Our Ref: TR/11577

30 September, 2020

RE: DEE WHY 7-ELEVEN PETROL STATION
RESPONSE TO MATTERS RAISED BY TfNSW

VEHICLE TURN PATHS

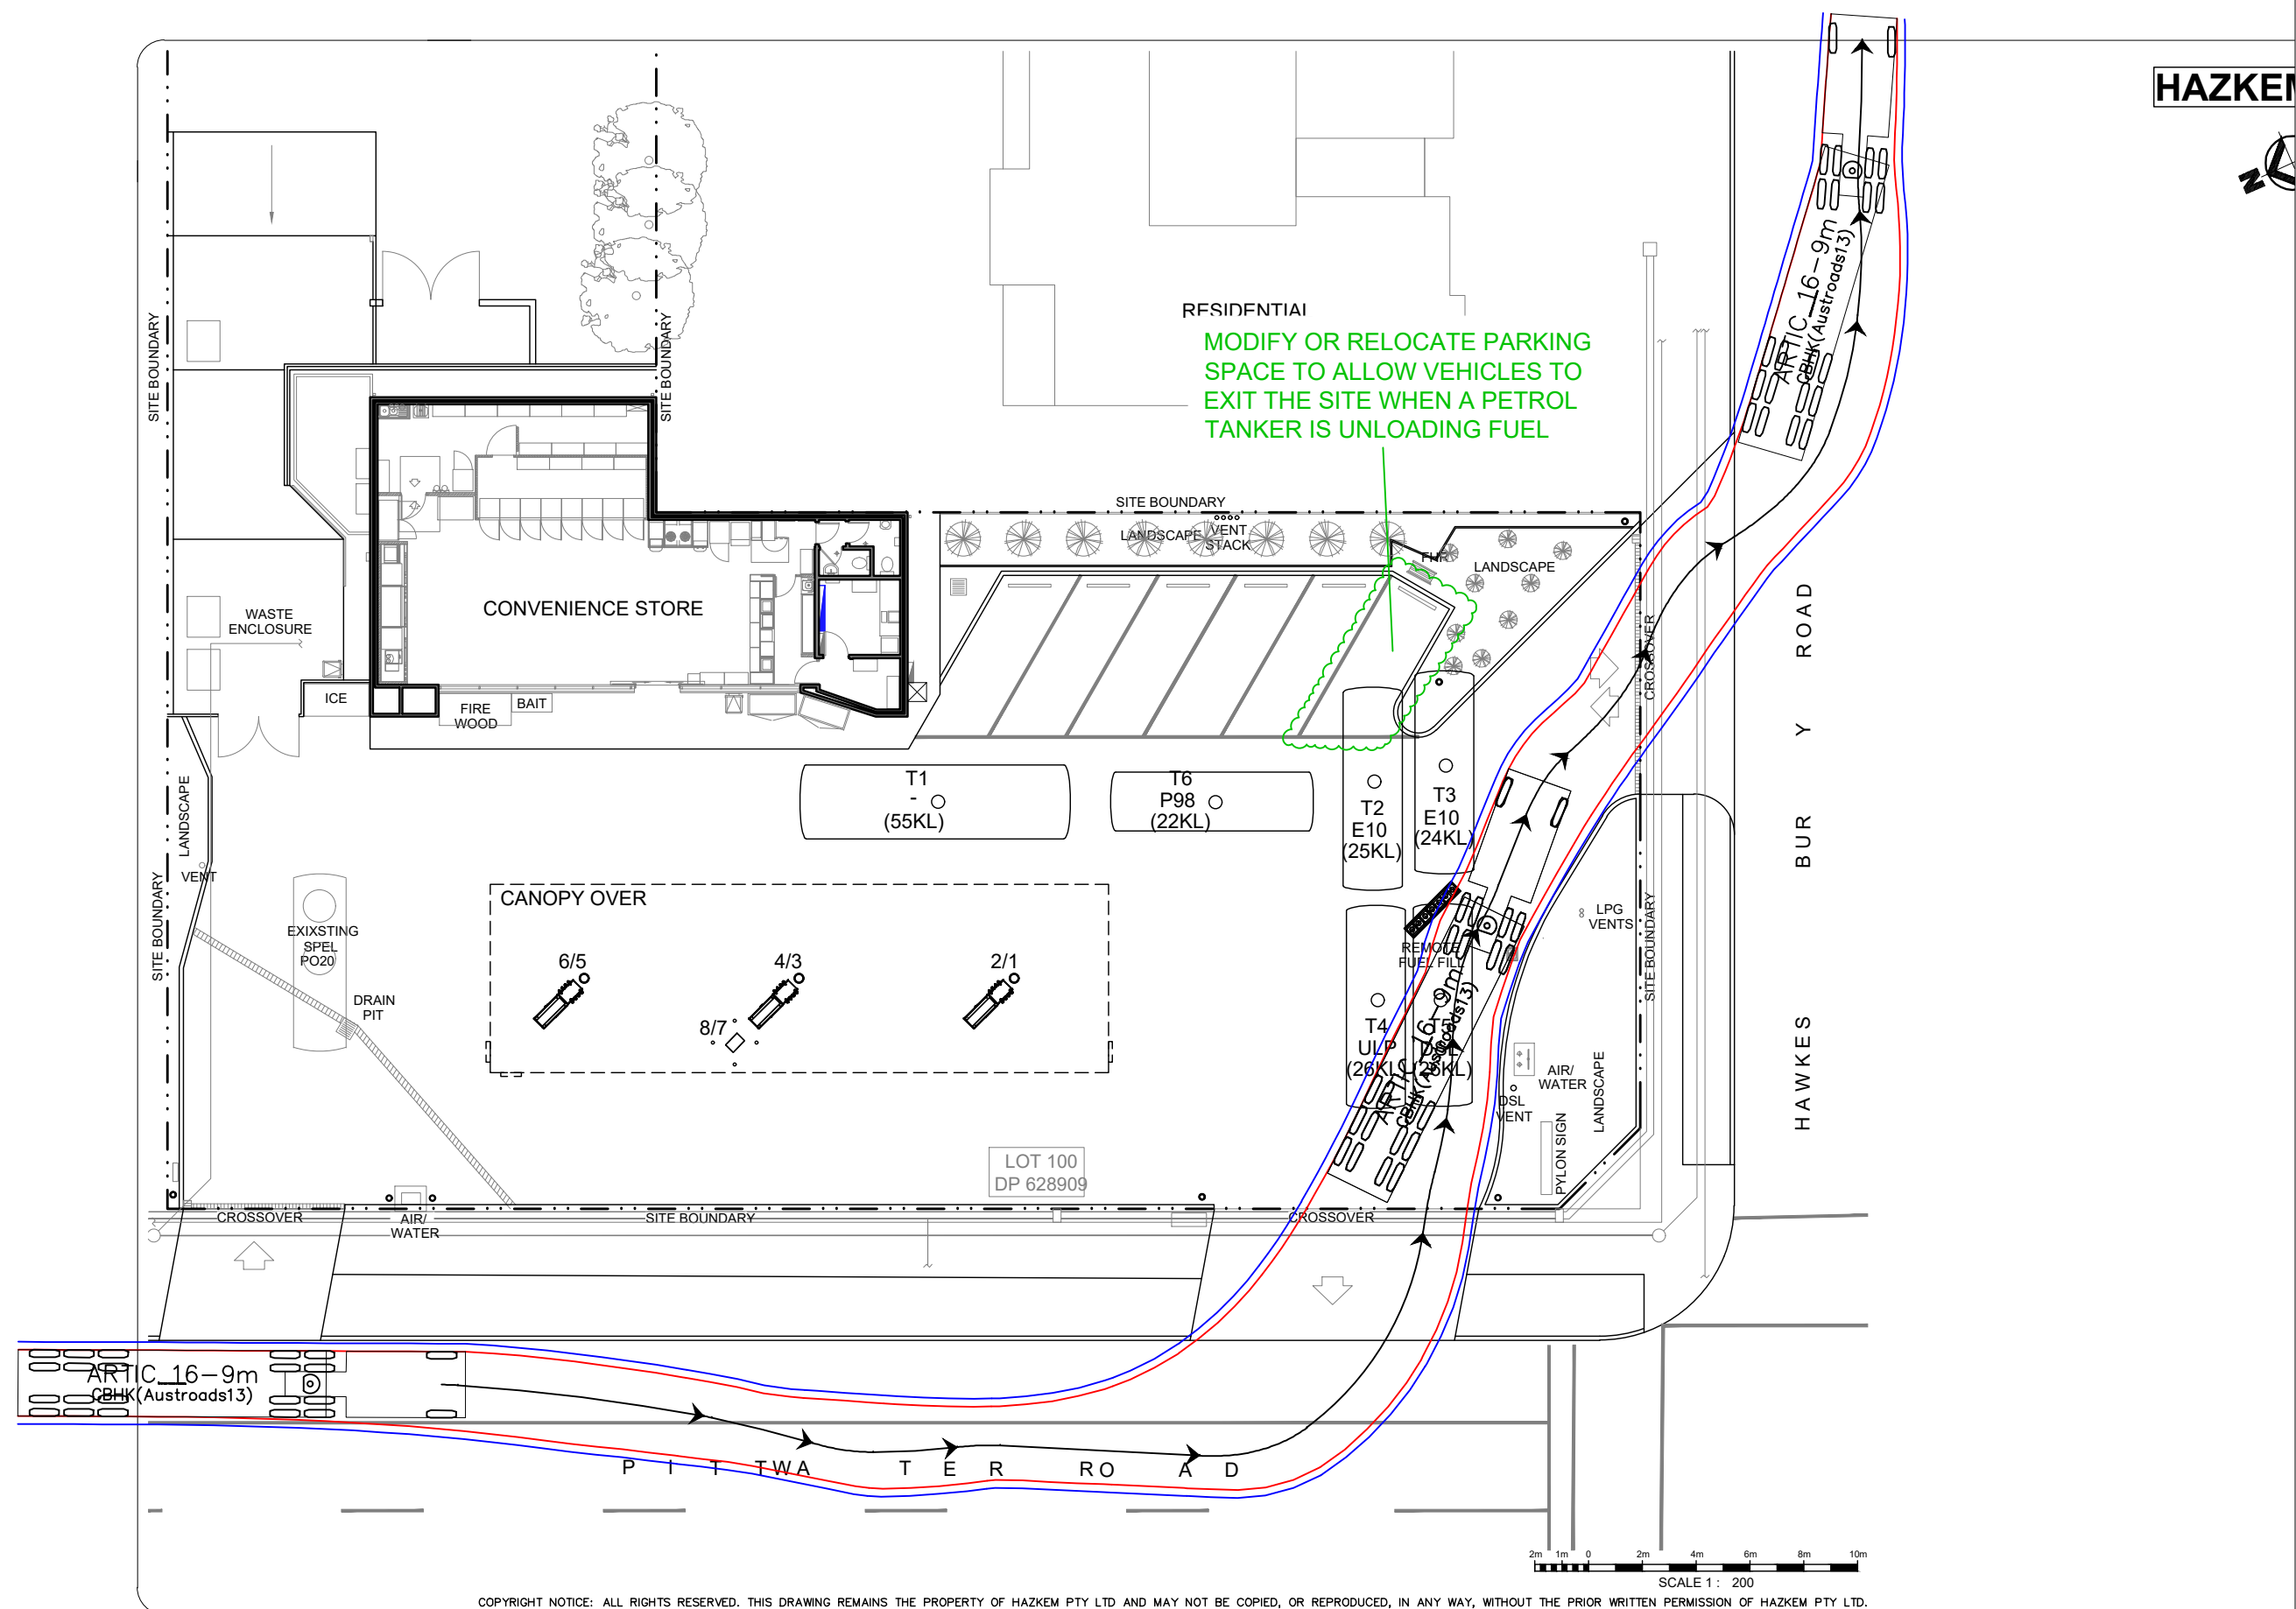
TfNSW has the concern that a tanker exiting through the driveway closest to the traffic signals at the intersection of Pittwater Road and Hawkesbury Avenue will have negative impact on road safety and traffic efficiency. The tanker should be able to turn fully and face the direction of travel prior to stopping at the signals. This is to ensure the pedestrian safety.

- I. *For example, the swept path plans in the current statement of environmental effects shows that during delivery fuel tankers will continue to deliver fuel at the site by entering at Hawkesbury Avenue and exiting onto Pittwater Road. This indicates that both exits will be blocked by the fuel tankers.*

- II. *Furthermore, the turn paths provided shows that tankers exiting through the driveway closest to the traffic signals at the intersection of Pittwater Road and Hawkesbury Avenue will have a negative traffic impact with the tanker effectively blocking two lanes of traffic during egress onto Pittwater Road.*

- III. *TfNSW notes that there is a vehicular access point on Pittwater Road at the northern boundary of the site. This access point should be used for ingress with egress onto Hawkesbury Avenue to avoid potential traffic conflicts*

- IV. *Updated swept path plans are to be provided indicating how vehicles (including garbage trucks, emergency and heavy rigid vehicles) will simultaneously ingress/egress the subject site via the above mentioned driveways. These plans shall be in accordance with AUSTROADS standards and are to show that vehicles can ingress/egress in a forward direction.*

- the tanker would enter the site via the southern driveway on Pittwater Road, park on the southern part of the site, unload fuel and then exit via a left turn onto Hawkesbury Avenue (this is the reverse of path of travel by the tanker for existing fuel deliveries);

- once the tanker is parked on-site and in position to unload, staff will advise customers (when paying for fuel or goods) to exit via Hawkesbury Road until the tanker departs. When unloading, the tanker will be in a similar position to the current situation;

- minor modifications to the landscape island and southern car space (parking space 5 - designate a small car space) to allow for access to Hawkesbury Avenue (as per the existing situation when the tanker is unloading); and

- relocation of parking space 6 to the western boundary.
6. The vehicle turn paths provided in Attachment B show the following vehicle swept paths:
 - the tanker entering the site via southern driveway on Pittwater Road and exiting via the Hawkesbury Avenue driveway;

- with the tanker parked unloading fuel, vehicles (cars and an 8.8 metre long rigid truck) exiting via Hawkesbury Avenue and the southern driveway on Pittwater Road; and

- at the Hawkesbury Avenue driveway, a car entering the site at the same time a 8.8 metre long rigid truck is exiting the site.
7. The above changes address the matters raised by TfNSW with respect to the truck exiting onto Pittwater Road in close proximity to the traffic signal controlled intersection. The path of travel for the tanker exiting the site is the same as that used by the tanker to enter the site. While the tanker is unloading, accessibility for the site is improved compared to the existing situation.

9. With regards to i), the attached swept paths show that with the revised tanker access arrangements and proposed minor modifications to the landscape area and car park adjacent to the Hawkesbury Avenue driveway, when a tanker is unloading fuel, vehicles can exit to Pittwater Road (via the southern driveway) or to Hawkesbury Avenue.

10. With regards to ii), this matter has been addressed through the tanker access arrangements for the tanker, with entry via the southern driveway on Pittwater Road and exit via a left turn onto Hawkesbury Avenue.

11. With regards to iii), the revised access arrangements provide for egress on Hawkesbury Avenue. With regards to entry for the tanker via the northern driveway from Pittwater Road, this option was considered and found not to be practical as:

13. Also with regards to iv), the vehicle swept paths have been prepared in accordance with AUSTROADS and the Australian Standards AS2890.1-2004 and AS2890.2-2018. These show that all vehicles can enter and depart the site in forward direction. Apart from the tanker, the 8.8 metre long rigid truck is the appropriate design vehicle as it covers the range of vehicles that could access the site including waste collection trucks, delivery trucks and emergency vehicles (police, ambulance and standard fire trucks).
